City of Surrey
PLANNING & DEVELOPMENT REPORT

File: 7914-0174-00

Planning Report Date: April 13, 2015

in order to permit the development of an oil change and car wash facility.

1 site
1 : 250

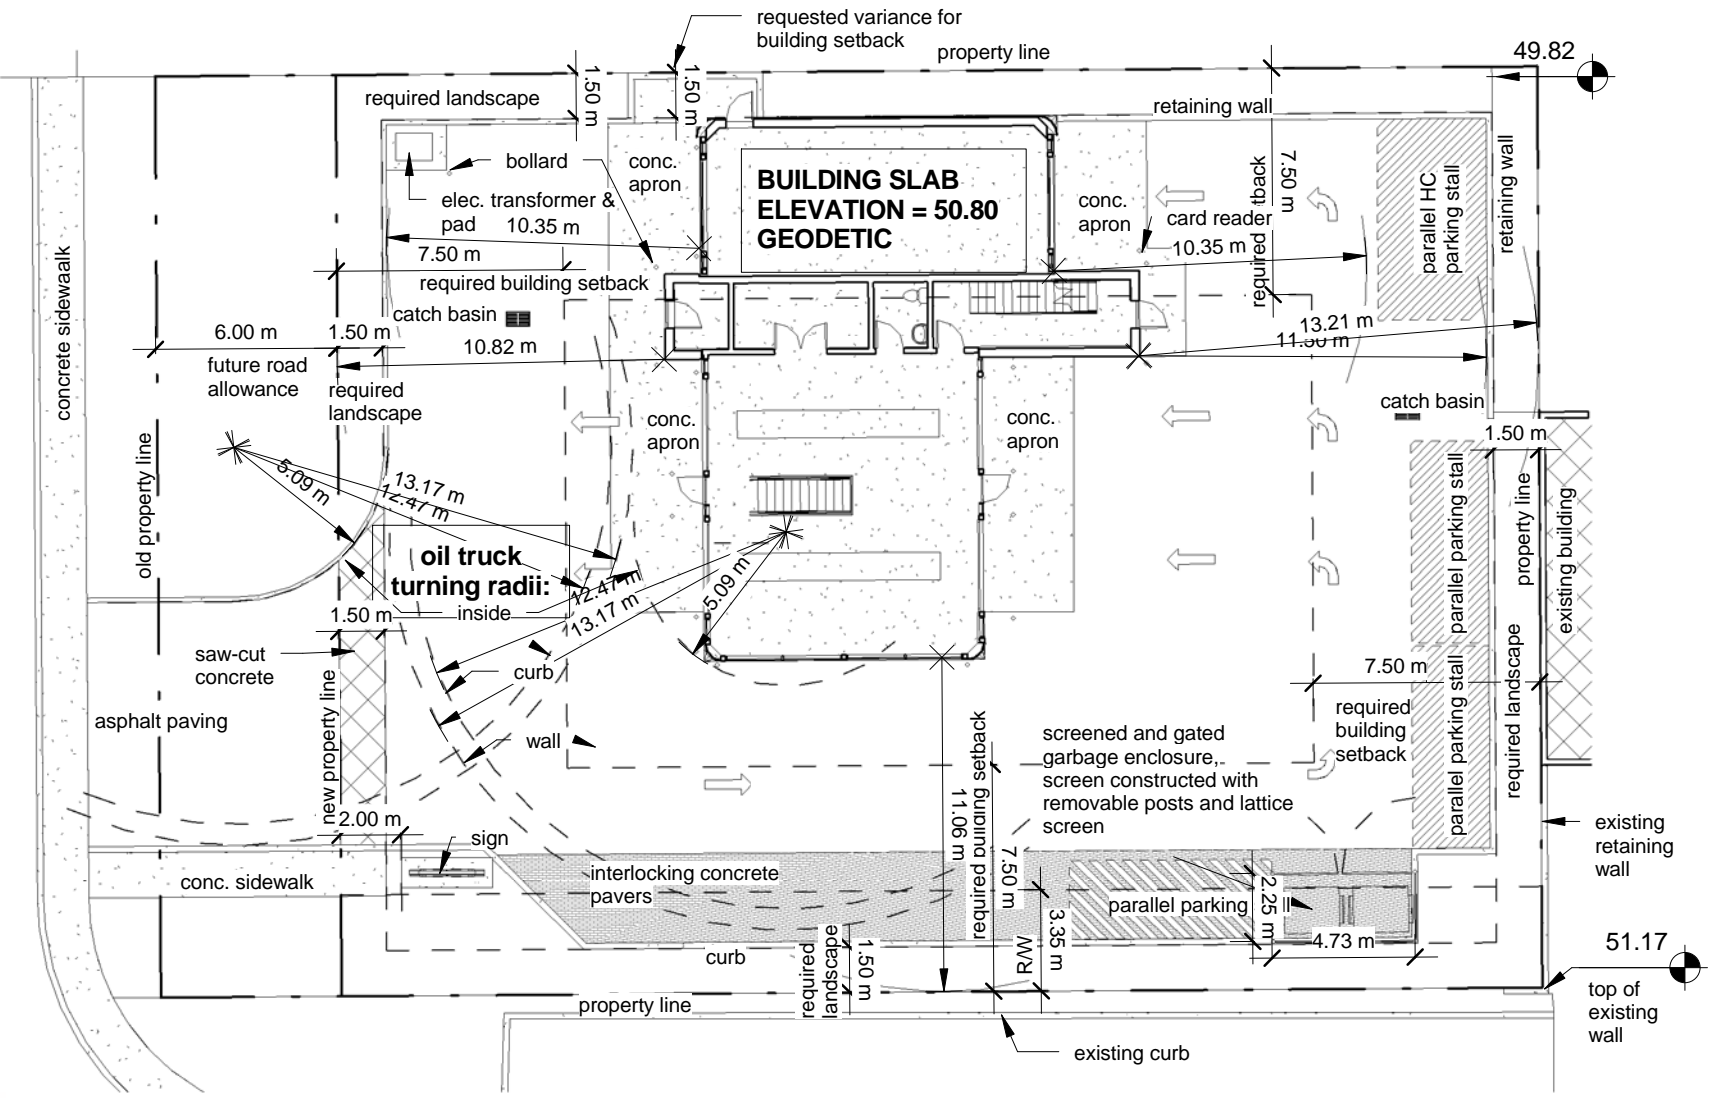
- The site is not large and the proposed north side yard setback relaxation is required to facilitate circulation on the small site.
- The adjacent site to the north is a motel. The building most affected by the proposed setback reduction contains the motel offices. The nearest units are located at least 20 metres (66 feet) away from the proposed building.

- The proposed parking relaxation from 5 parking spaces to 4 parking spaces is supportable due to the nature of the proposed use (customers stay in their cars while using the car wash or getting their oil changed).
- The site has sufficient queuing storage for waiting customers.

Setbacks	Permitted	Proposed
Front	7.5 m	10.82 m (from new property line)
Rear	7.5 m	13.21 m
Side (north)	7.5 m	1.5 m (variance required)
Side (south)	7.5 m	11.06 m

east elevation scale 1:250

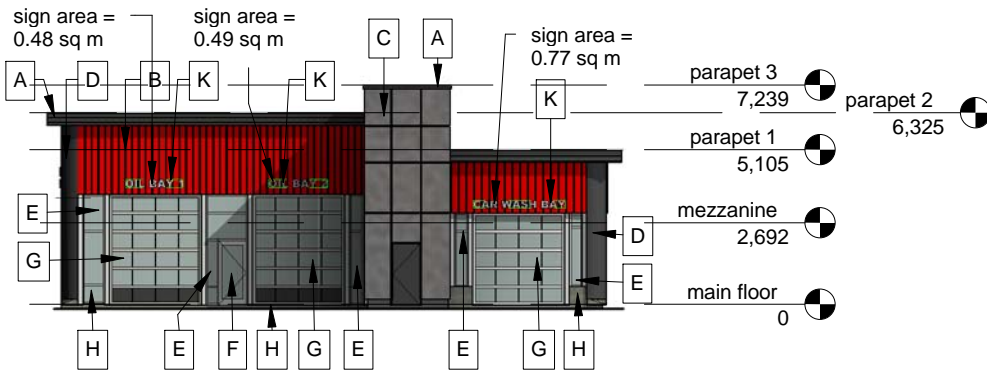
- The proposed signage is channel letter signage or backlit corporate signage, is within the maximum permitted sign area and is appropriate in relation to the scale of the building. Three (3) of the proposed signs are on the rear (east) elevation of the building and simply identify the oil change and car wash bays. The 3 signs at the rear elevation of the building are not visible from King George Boulevard.
